## Determination of a Site Plan Determination/Exemption Request

Project Name: 1500 W Stassney Ln DA-2018-0230

Address: 1500 W STASSNEY LN

**Determination of a Site Plan Determination/Exemption Request**

PROPOSED SITE PLAN EXEMPTION  
SCALE: 1" = 30'

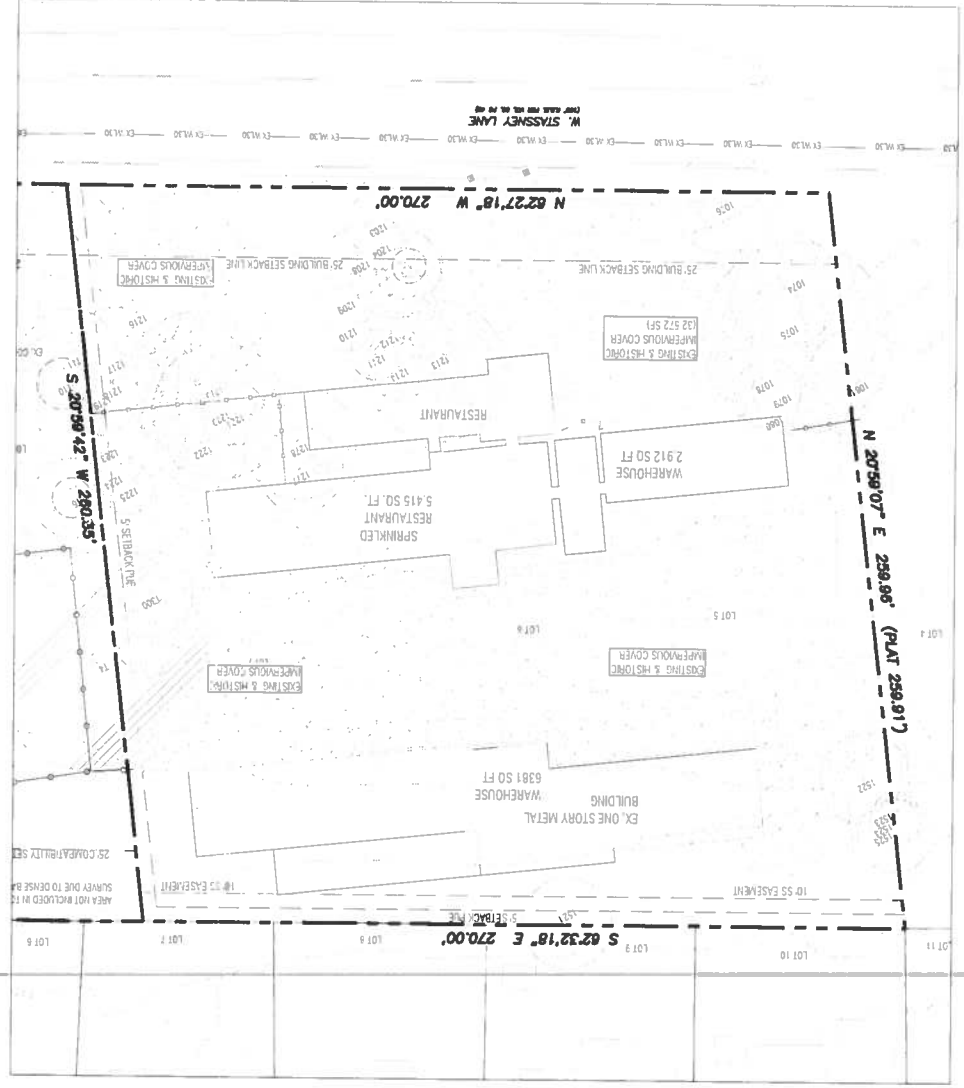
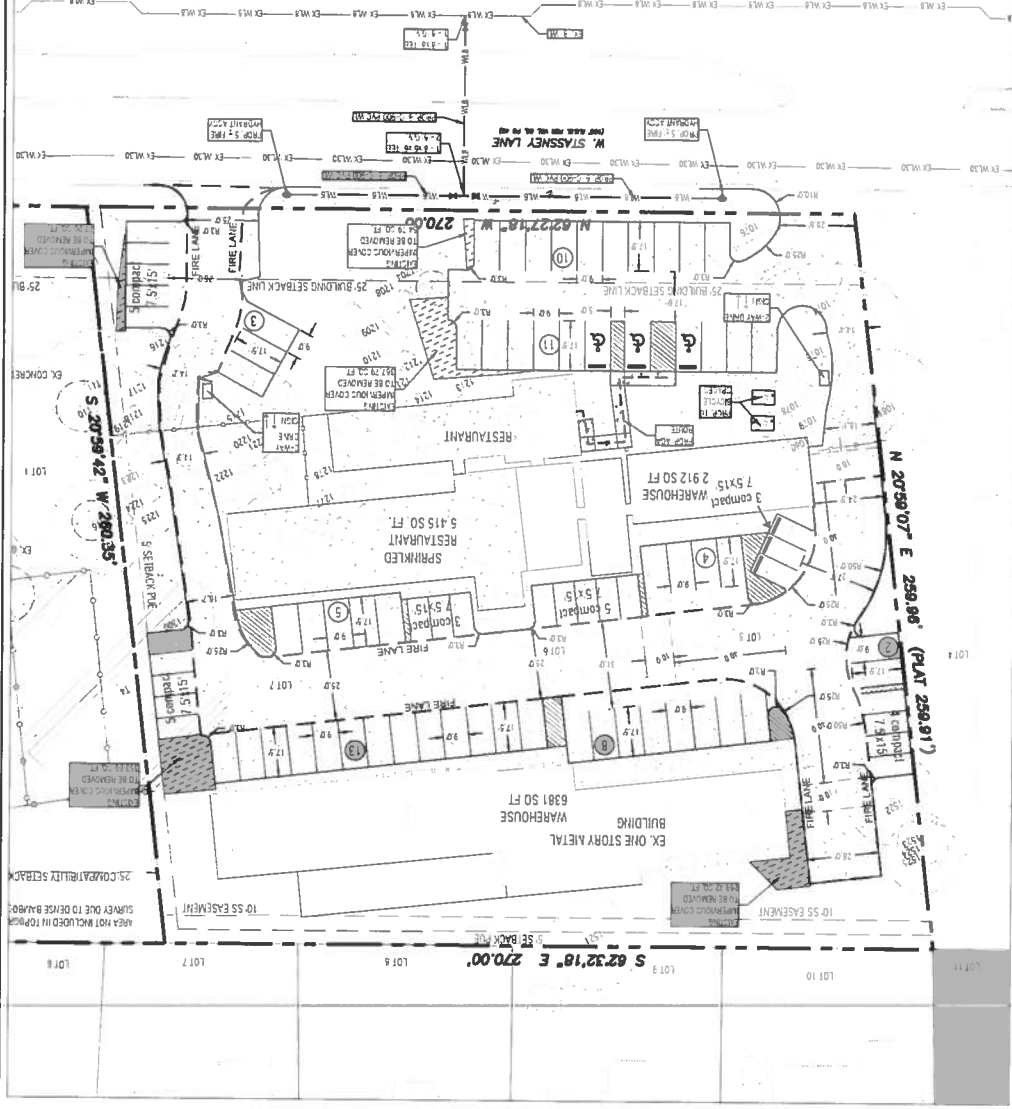
Viktor Auzenne – Based on current conditions it appears that a significant portion of the area claimed to be historic existing impervious cover has not been maintained and revegetated and may not be considered existing for this request. This area must be calculated as new development.

Accessible parking and paths must be provided to each use.

Kristin Carlton – a big portion of the historical impervious cover has not been utilized consistently or maintained since 1987. Much of the proposed will require a new site plan.

AFD – C. Mendoza – Proposed fire lane must be a minimum 25’ wide with an undisturbed vertical clearance of 14’. IFC 503.2.1

Restaurant fire areas exceed ? which require sprinkler system. IFC 903.2.1.2

Show F.H. Lock ins. 1 hydrant within 400’ 2<sup>nd</sup> within 500’ of all exterior portions. IFC 507.5.

The layout we discussed in the meeting is approved by AFD. All proposed buildings are within the access and fire hydrant distance requirements per the IFC. We also agreed that the fire lane less than 25ft on the east side of the building will be used as a drive through only. If you have any other questions or concerns, feel free to contact me.
